SUNDRY NOTICES AND REPORTS ON WELLS

8. Well Name and No.
Brook Federal #5

Mack Energy proposes to change TD depth to 10,500'. Proposed change to casing, cement program.

CONDITIONS OF APPROVAL

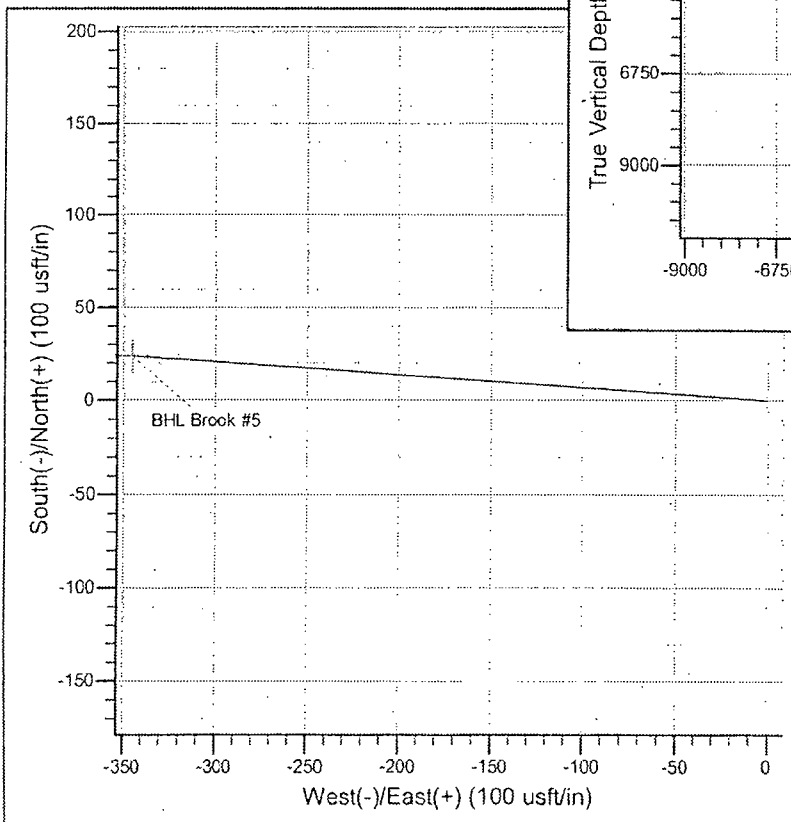
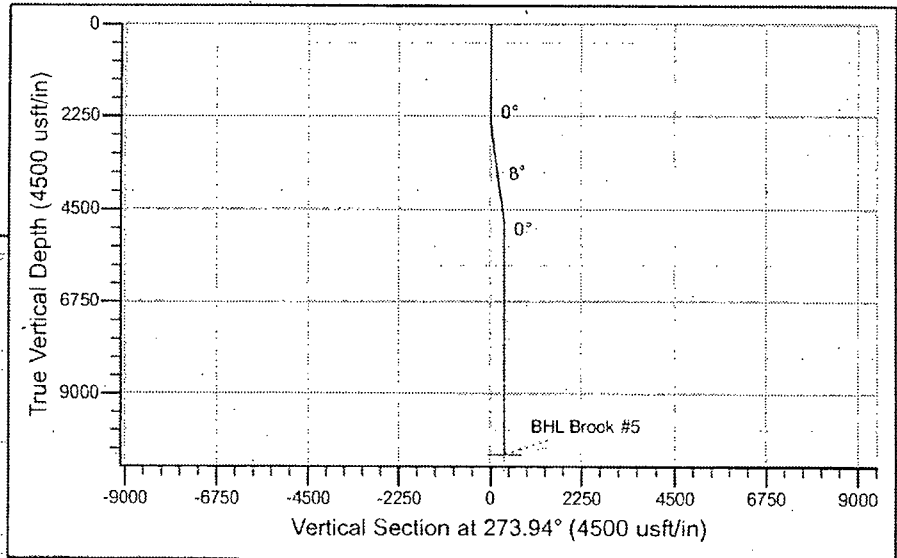
1650FNL and 330FEL are hard lines.
The well can be south, west, or southwest of these hard lines but not north, east, or northeast. From the BHL the well is 25' south of the north hardline and 25' west of the east hardline. Note the BHL has been changed to give a buffer from what is on the plat.
